From: [REDACTED]
Sent: Wednesday, April 9, 2025 10:02 AM
To: Momo Hei Ching CHOW/PLAND <mhcchow@pland.gov.hk>
Subject: Re: A/YL-TT/691 (Departmental Comments)

有關環境保護署對 A/YL-TT/691 的查詢

Compliance with Approval Condition (c)
Planning Application No. A/YL-TT/570

Compliance with Approval Condition (f) **Planning Application No. A/YL-TT/570**

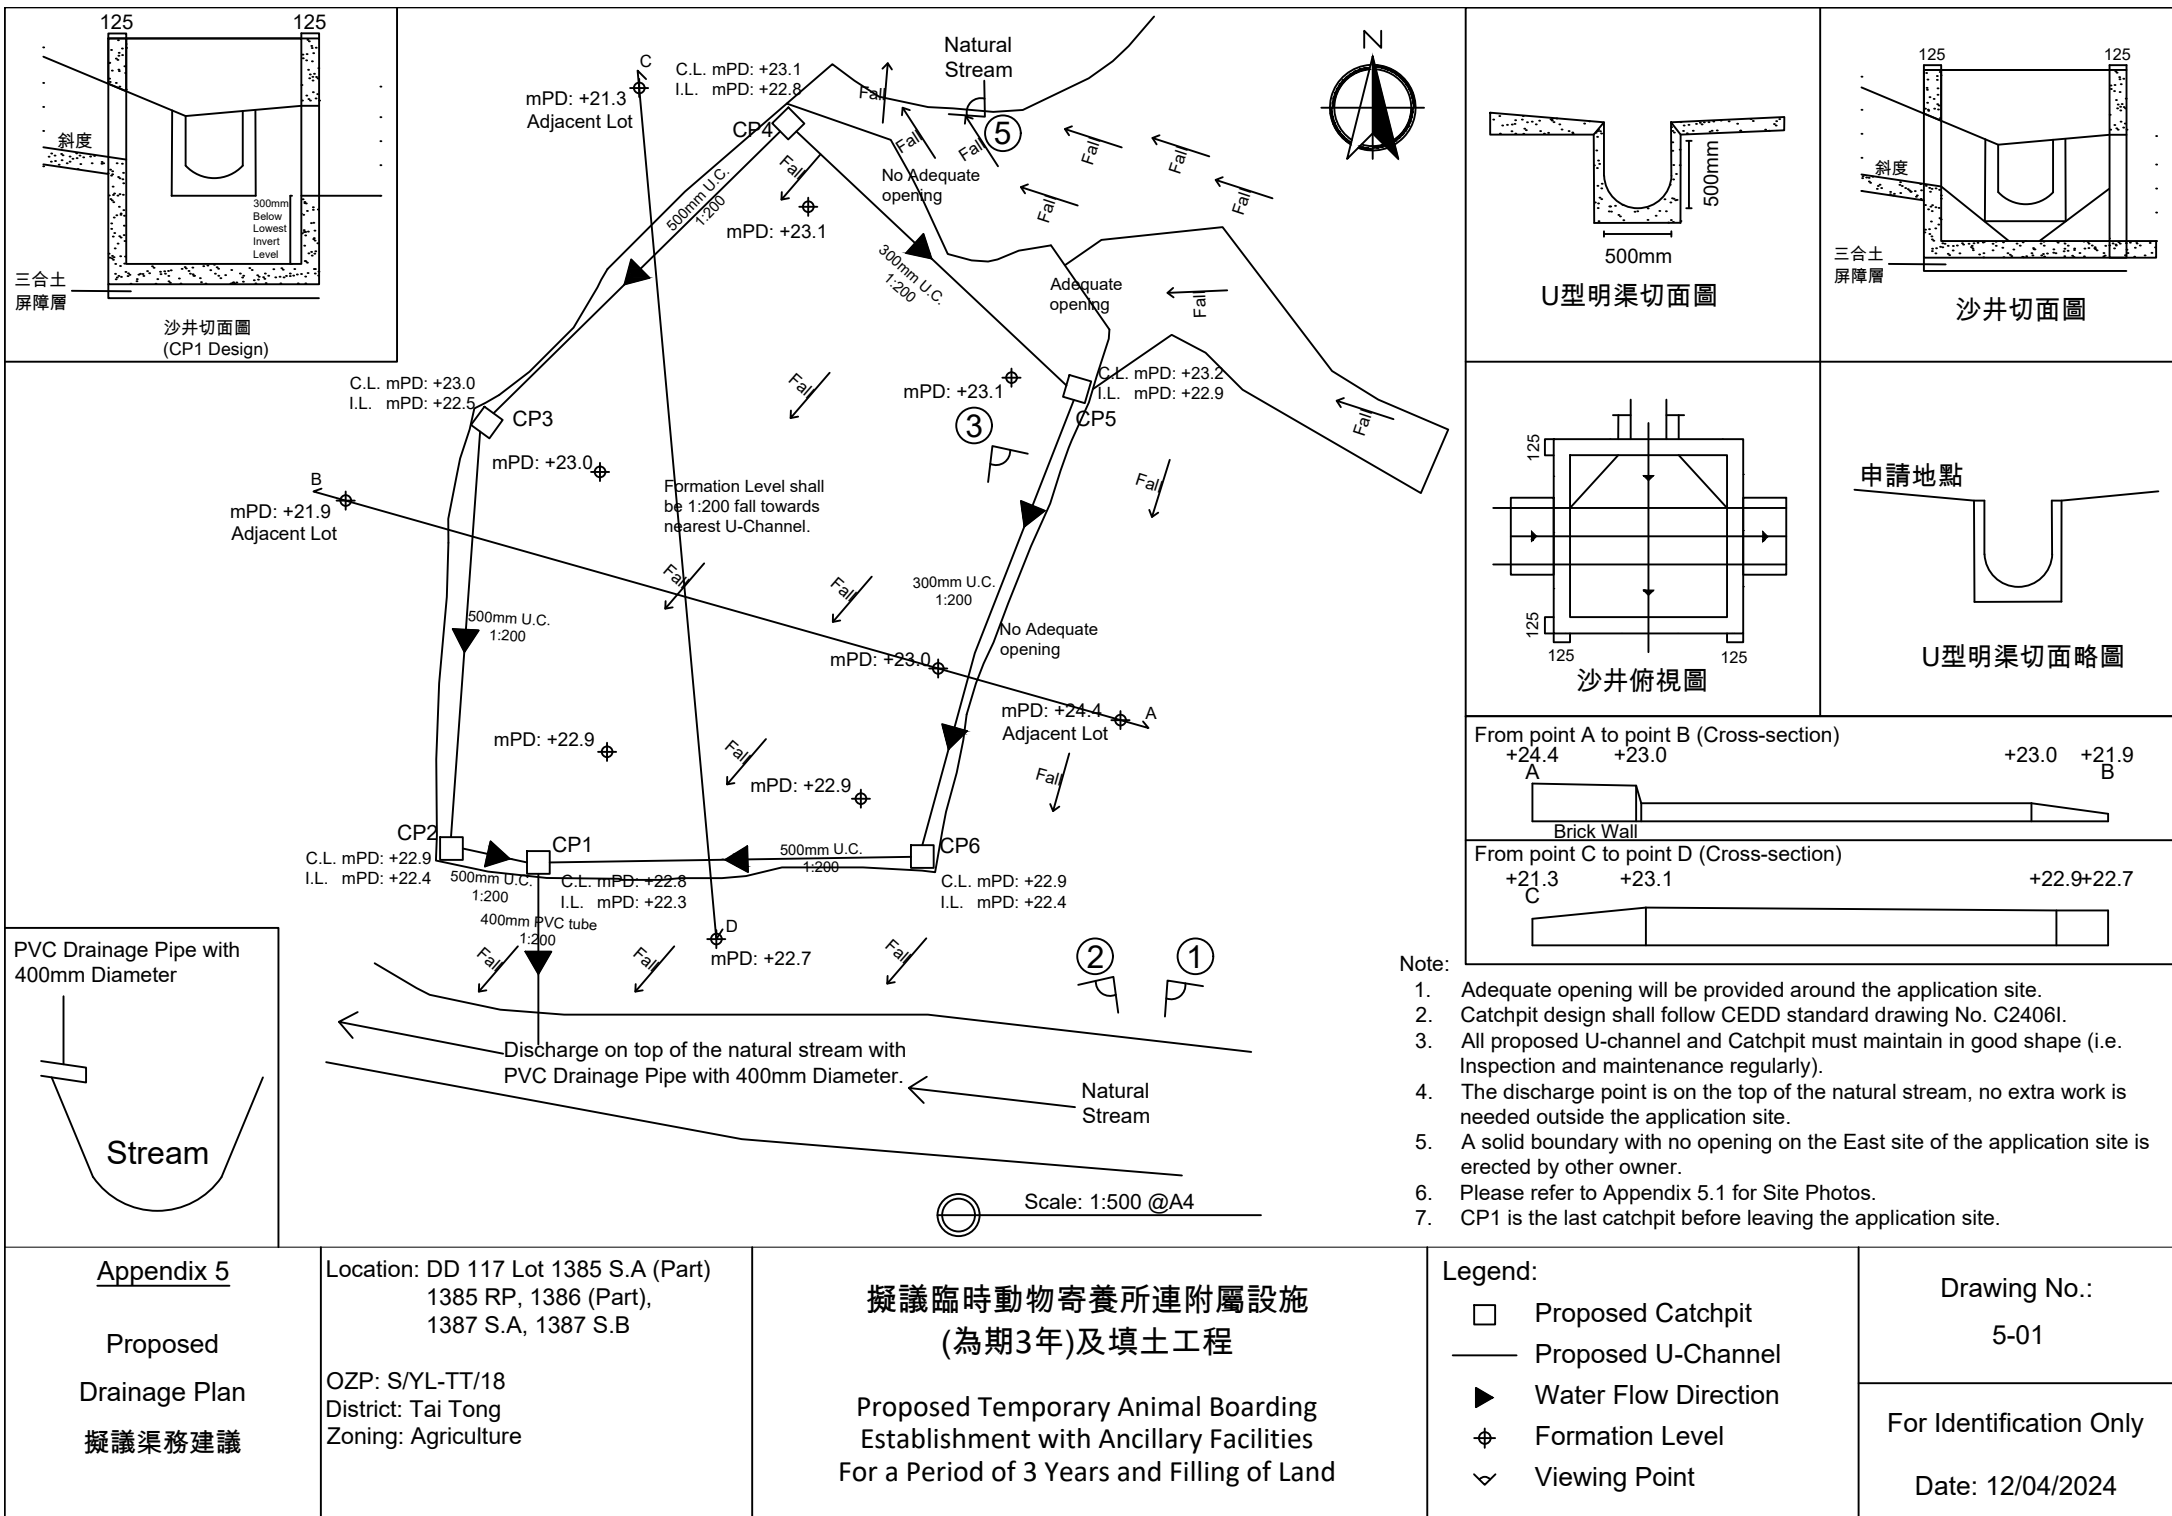
I refer to your submission dated 12.4.2024 for compliance with the captioned approval condition (c) on the submission of a drainage proposal. The Drainage Services Department (DSD) has been consulted on your submission. Your submission is considered:

- ☒ Acceptable. The captioned condition **has been complied** with. Please find detailed departmental comments at **APPENDIX**
- ☐ Acceptable. Since the captioned condition requires both the submission and implementation of the proposal, it **has not been fully complied with**. Please proceed to implement the accepted proposal for full compliance with the approval condition.
- ☐ Not acceptable. The captioned condition has **not** been complied with.

Proposed Fire Service Installation Plan

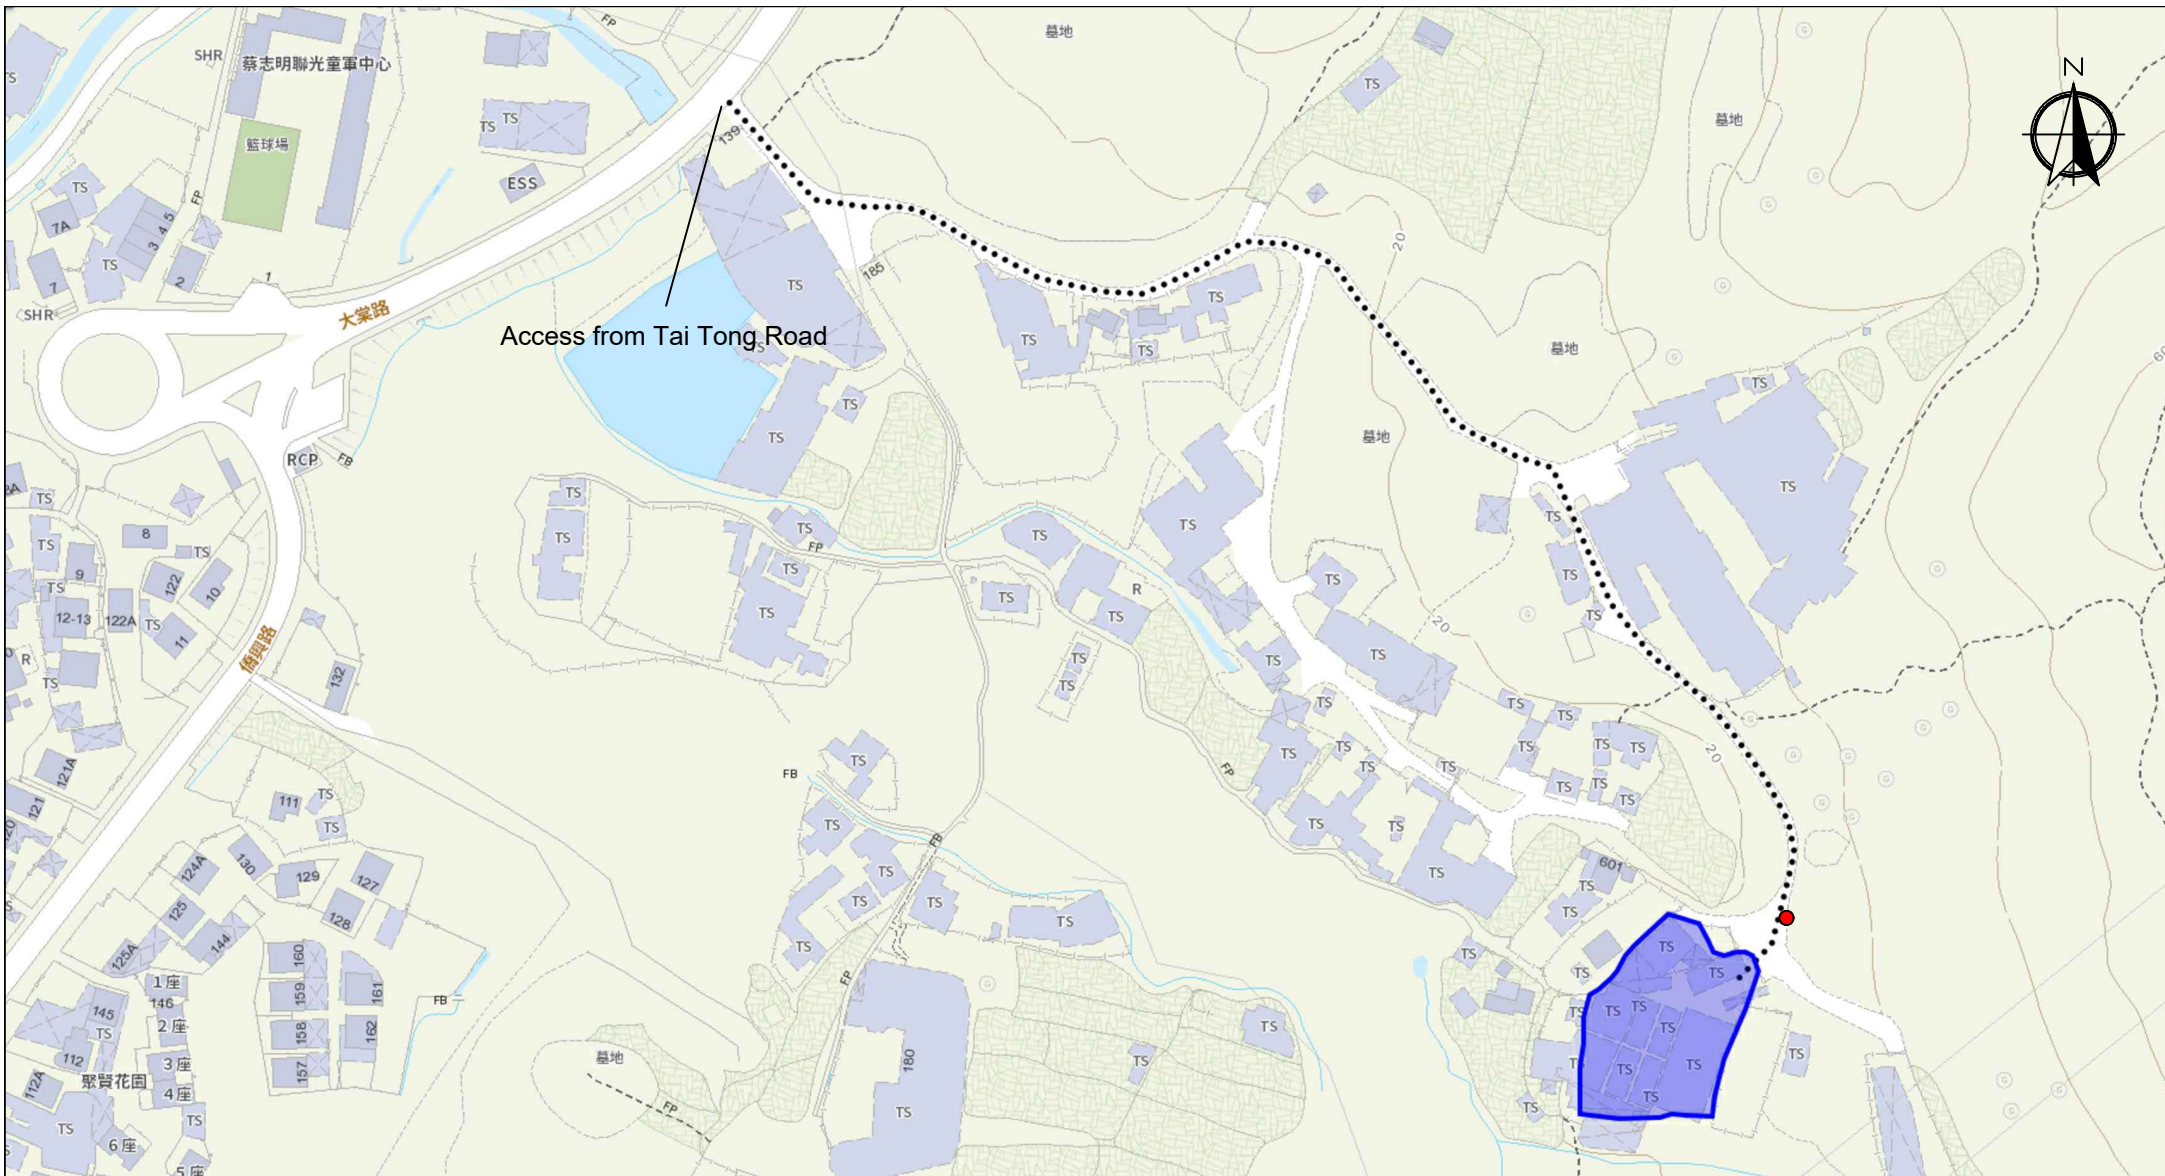
I refer to your submission dated 18.1.2023 for compliance with approval condition (f) on the submission of a fire service installations proposal to the satisfaction of the Director of Fire Services or of the Town Planning Board. The Fire Services Department (FSD) has been consulted on your submission. Your submission is considered:

- ☒ Acceptable. The captioned condition **has been complied** with. Please find detailed departmental comments at **APPENDIX**.
- ☐ Acceptable. Since the captioned condition requires both the submission and implementation of the proposal, it **has not been fully complied with**. Please proceed to implement the accepted proposal for full compliance with the approval condition.
- ☐ Not acceptable. The captioned condition has **not** been complied with.

*All FSI (includes installation/maintenance/modification/repair work) will be completed by RFSIC.

*All the enclosed structures are provided with access for emergency vehicles to reach within 30m travel distance from the structures.
